Addendum No. 2 to Brightwater Final EIS

Brightwater Regional Wastewater Treatment System

Addendum 2

April 2004

Figure 1-1
Ballinger Way Portal (5) Selected Site
BRIGHTWATER REGIONAL
WASTEWATER TREATMENT SYSTEM

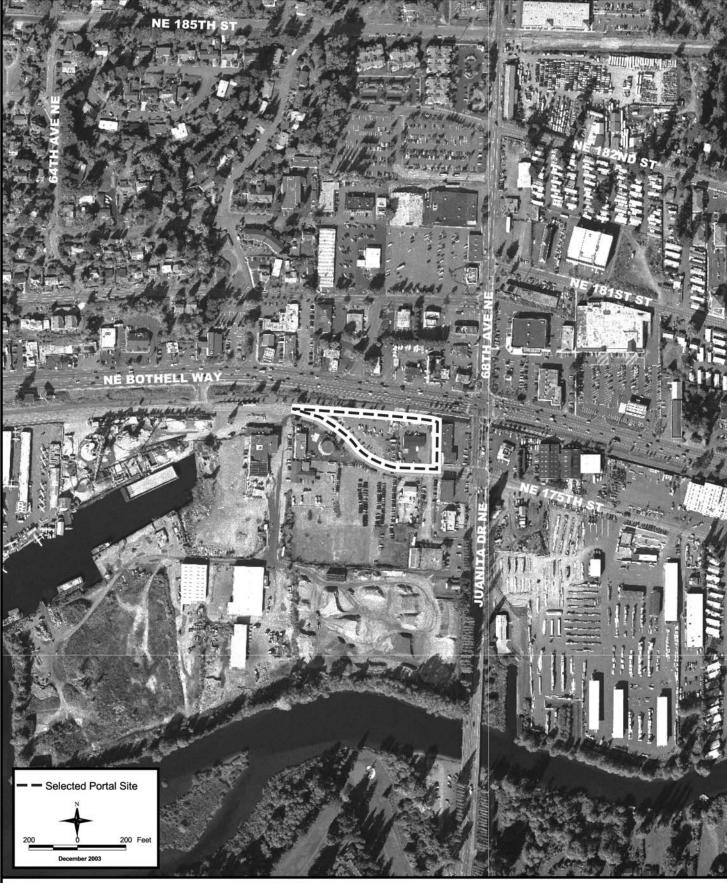
Sites selected for Portals 11 and 41 are the same as their respective candidate sites illustrated in the Final EIS in Figures 3-26 and 3-40, respectively. Sites selected for Portals 5 and 19 are smaller than the candidate sites illustrated in the Final EIS in Figures 3-23 and 3-30, respectively, because the larger sites are not needed. However, the selected site illustrated in Figure 1-5 of this Addendum for Portal 44 is larger than the specific candidate site illustrated in the Final EIS in Figure 3-41, but well within the 72-acre portal site identified and evaluated in the Draft EIS.

FIGURE 2-1
PORTAL 19 CONSTRUCTION LAYOUT
BRIGHTWATER FINAL EIS ADDENDUM NO. 2

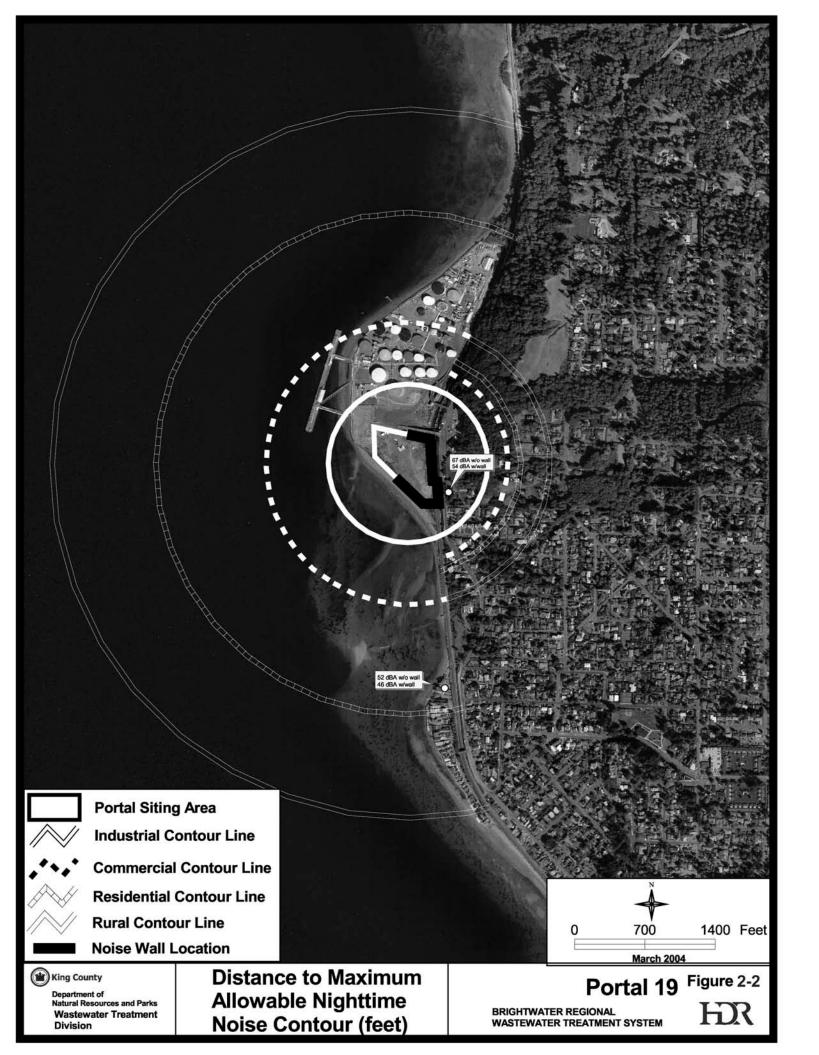
Portal 19 is located adjacent to Puget Sound, approximately 150 feet west of Richmond Beach Drive NW, on the southern portion of the ChevronTexaco barge dock. Portal 19 would serve as a working portal to support the construction of approximately 21,000 feet of effluent tunnel extending eastward toward Portal 5, which would be located near NE 205th Street and Ballinger Way NE. Portal 19 would also serve as a connection point to the outfall (Figure 2-1).

The Final EIS indicated the possible construction method that could be used at Portal 19 is interlocking sheet pile walls with a jet grout invert plug. The probable portal construction method has been modified to concrete slurry walls with a jet grout or concrete tremie invert slab, to address geotechnical considerations at the site.

Figure 3-1 Route 9 – Access Road Site Plan

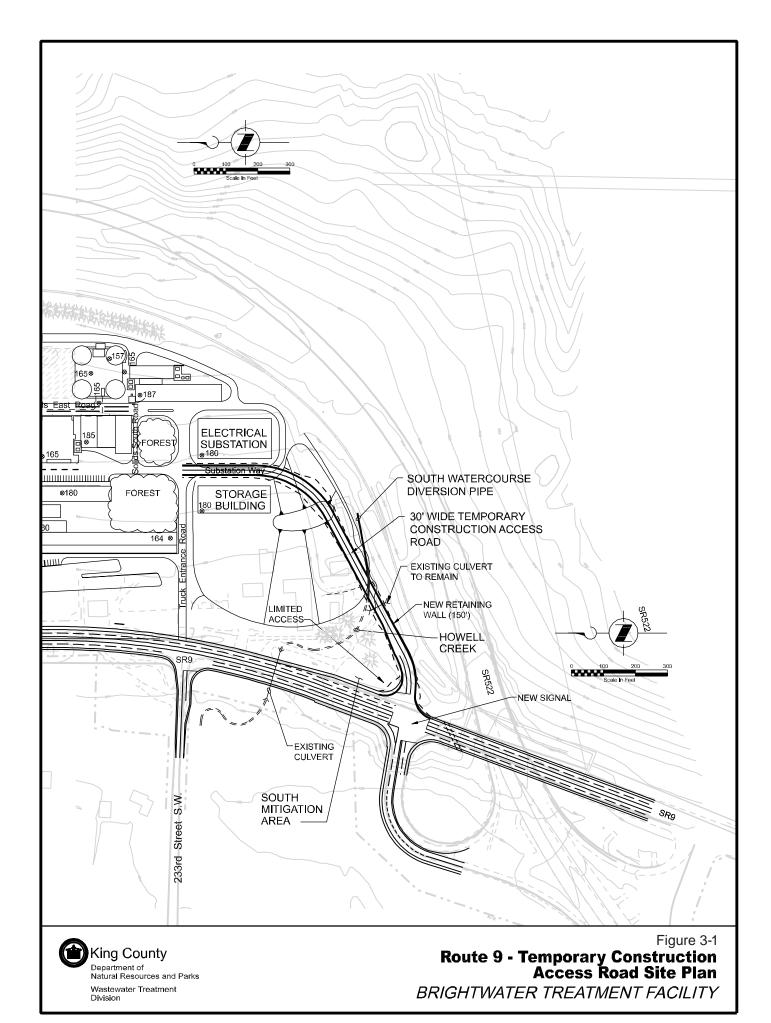
The Final EIS assumed construction access to the Route 9 site primarily at the intersection of SR-9 and 228th Street SE, with a secondary access from SR-9, south of 228th Street SE. King County is now proposing a temporary construction access road at the SR-9/SR-522 westbound ramp intersection, which would replace both of the previously proposed access locations. The access road at the SR-9/SR-522 westbound ramp intersection would accommodate all construction trips and would materially reduce construction trips and construction-related traffic along SR-9 north of SR-522. This new access road is south of 228th Street SE, consistent with the location description in the Final EIS.

The new construction access road to the Brightwater site would be located opposite the existing westbound SR-522 interchange ramp, as shown in Figure 3-1. Use of the roadway would be restricted to Brightwater construction traffic and potentially SR-9 construction traffic. WSDOT plans to signalize the SR-9/SR-522 westbound ramp intersection as part of the SR-9 improvement project, although it is likely that WSDOT would not signalize the intersection until late in the SR-9 project schedule. To further mitigate traffic impacts, King County proposes acceleration of the signal installation to early in the WSDOT project schedule.

Access road construction would delay the completion of proposed mitigation in the southern tip of the project site adjacent to Howell Creek (referred to as the South Mitigation Area as shown on Figure 3-1) and the proposed reconstruction of Howell Creek until 2009 when the use of the access road is complete. The alignment of the proposed construction access road crosses the southernmost part of the proposed South Mitigation Area. That portion of the South Mitigation Area beyond the limits of the construction access road would be constructed concurrently with the construction access road; however, construction of the remaining mitigation area would not be completed until after the construction access road is removed. At the conclusion of the project, the construction access road embankment and remaining portions of the existing driveways and culverts would be removed and any remaining elements of the South Mitigation Area would be completed.

Figure 3-2 Route 9 – Access Road Section

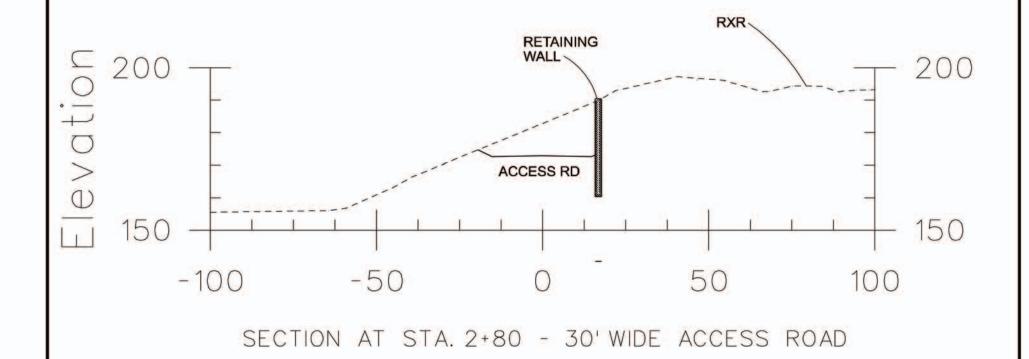
A cross-section of the proposed construction access road on the east side of the westbound SR-522 ramp intersection is shown in Figure 3-2. The two-way roadway would be 30 feet wide and approximately 1,000 feet long along the southern boundary of the plant site. Roadway grade would be approximately 7 percent to match existing terrain. A retaining wall, approximately 15 feet high by 150 feet long, would be required along a portion of the roadway to retain and stabilize the anticipated cut excavations due to the roadway construction.
